### **ADDENDUM # 3**

Date: 10/9/2024

#### **IFB #2945 Sheriff's Office District 3 Renovation**

1 FINISH PLAN - FIRST FLOOR  
1/4" = 1'-0"

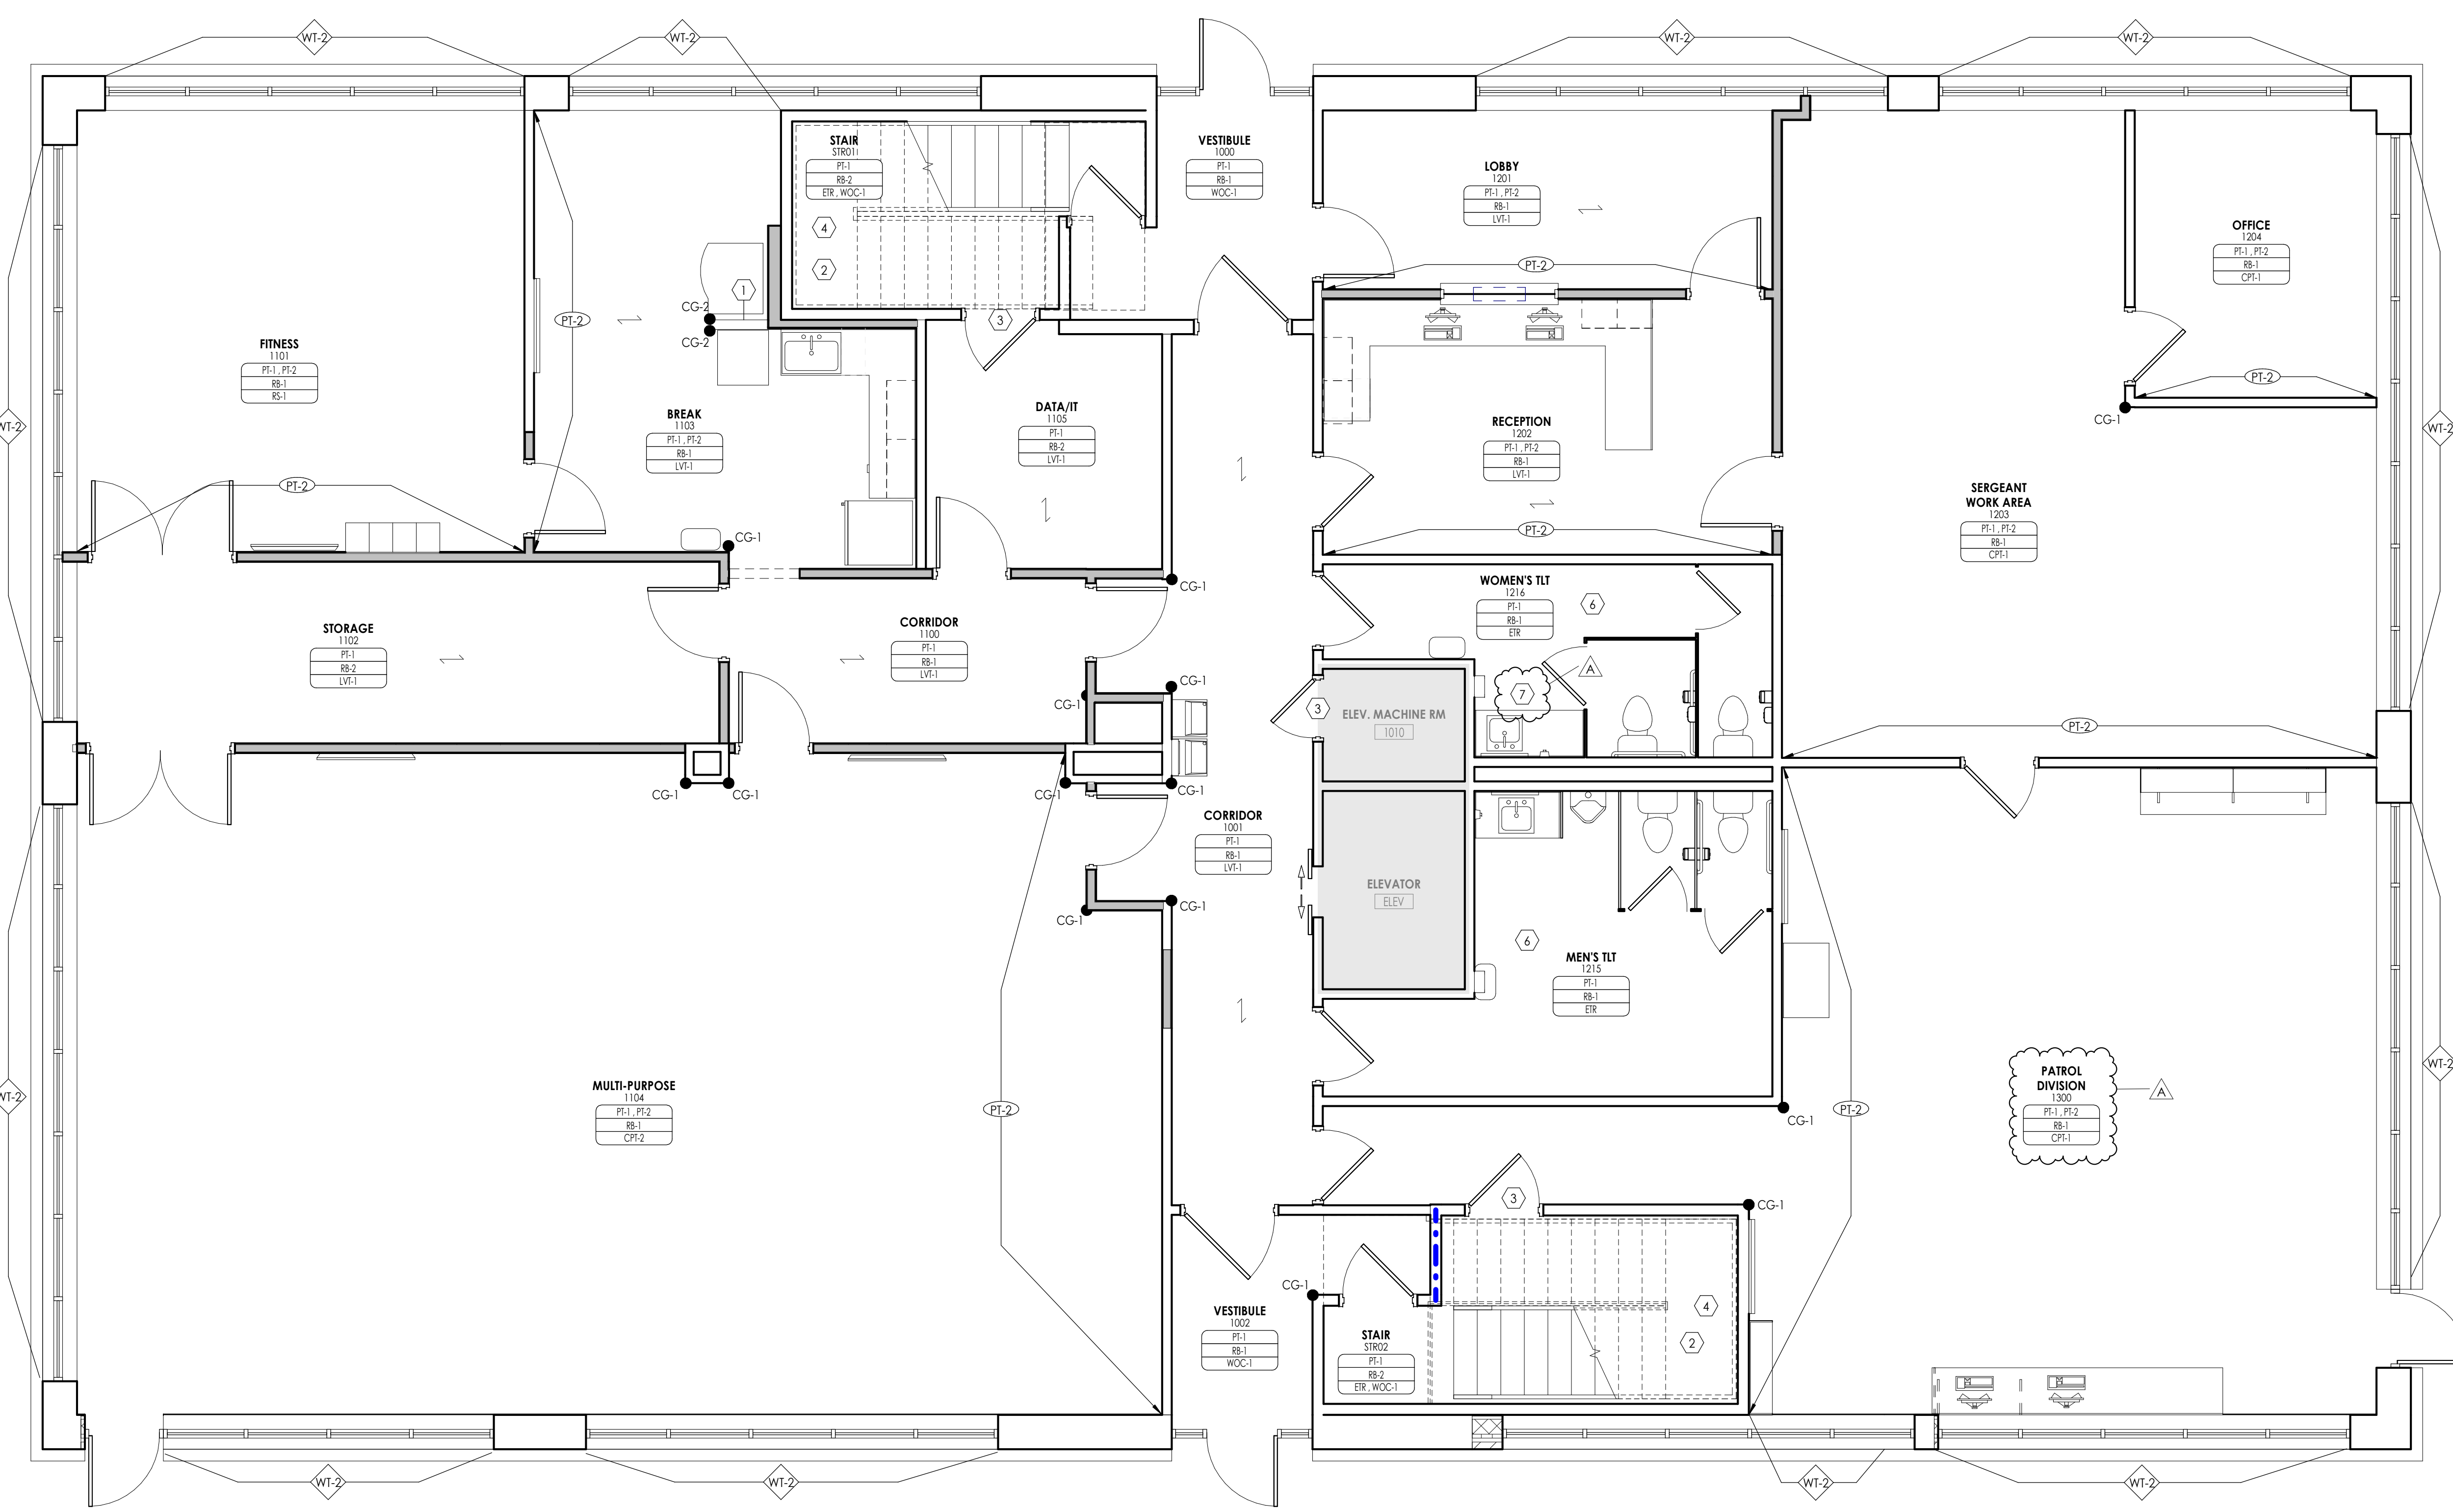
C.ADD Alternate No. 03: Provide new tile floor, tile base, and toilet partitions in Rooms 1215 & 1216

- PROVIDE NEW TILE FLOOR. TILE BASE AND TOILET PARTITIONS IN ROOMS 1215 AND 1216.
- PROVIDE NEW TILE FLOOR. TILE BASE AND TOILET PARTITIONS IN ROOMS 2001 AND 2002.

1 FINISH FLOOR PLAN - SECOND FLOOR  
1/4" = 1'-0"

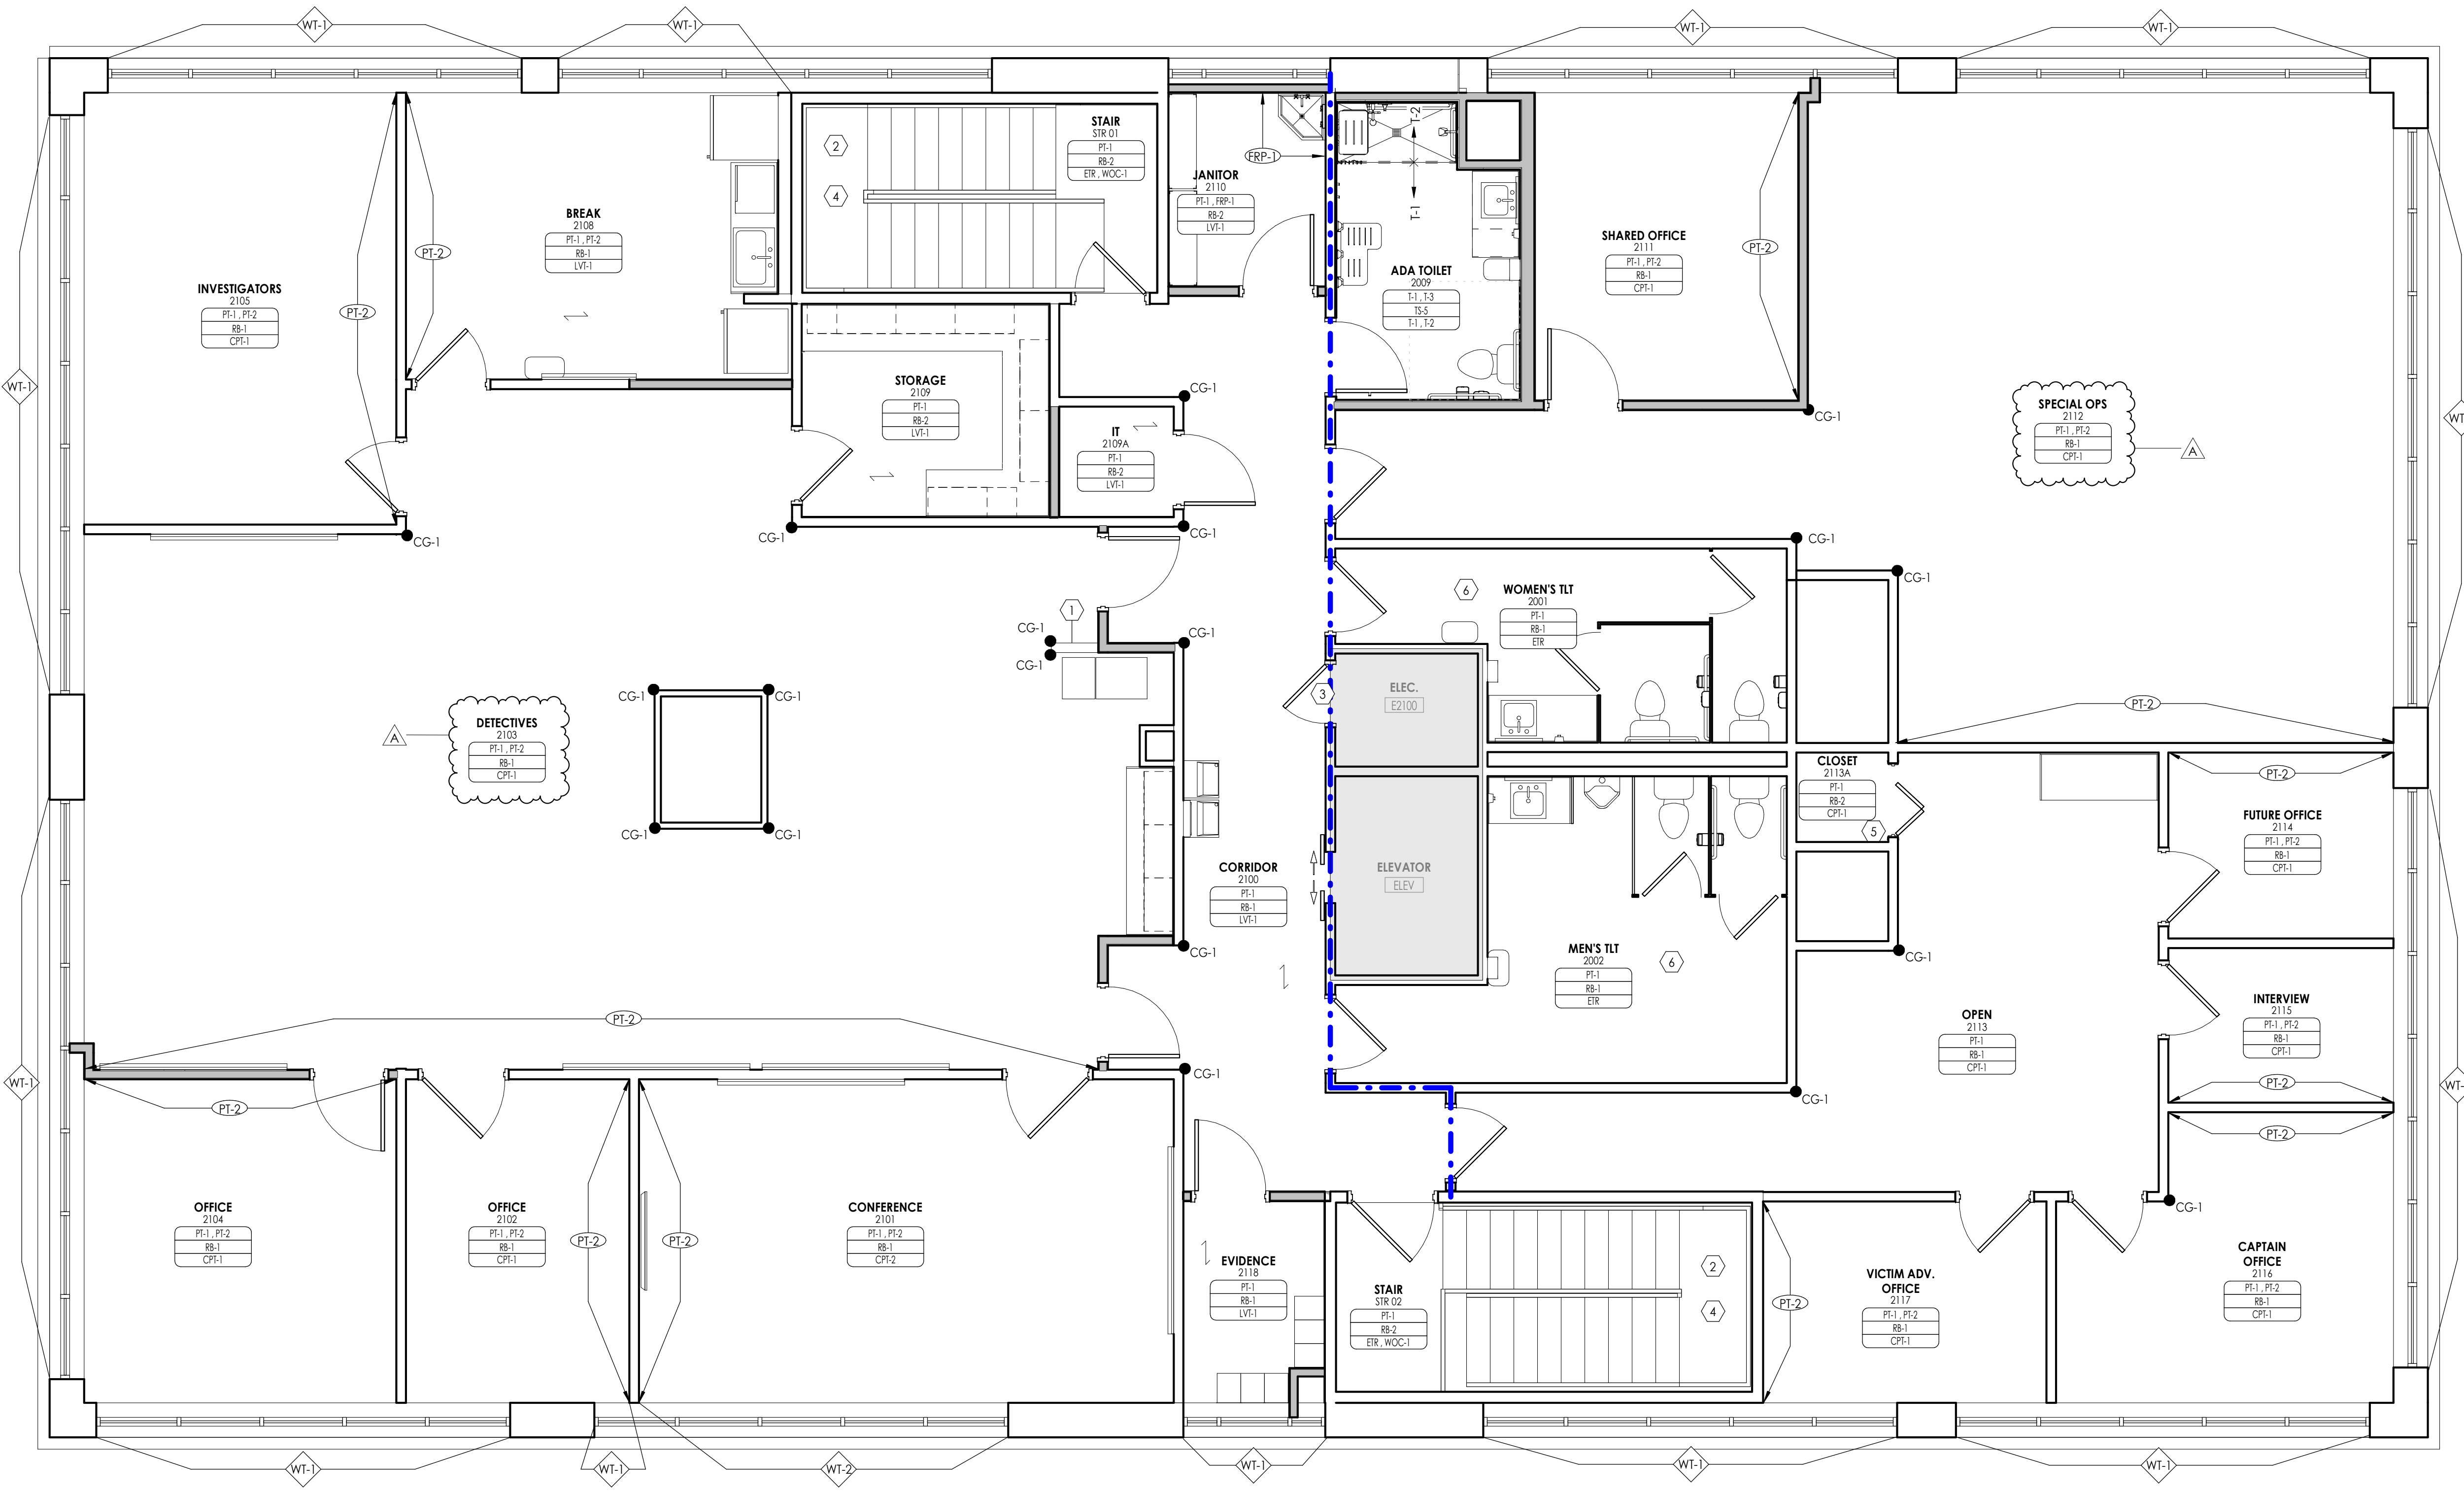
. ADD Alternate No. 04: Provide new tile floor, tile base, and toilet partitions in Rooms 2001 & 2002

3. PROVIDE NEW TILE FLOOR, TILE BASE AND TOILET PARTITIONS IN ROOMS 2125 AND 2126.
4. PROVIDE NEW TILE FLOOR, TILE BASE AND TOILET PARTITIONS IN ROOMS 2001 AND 2002.
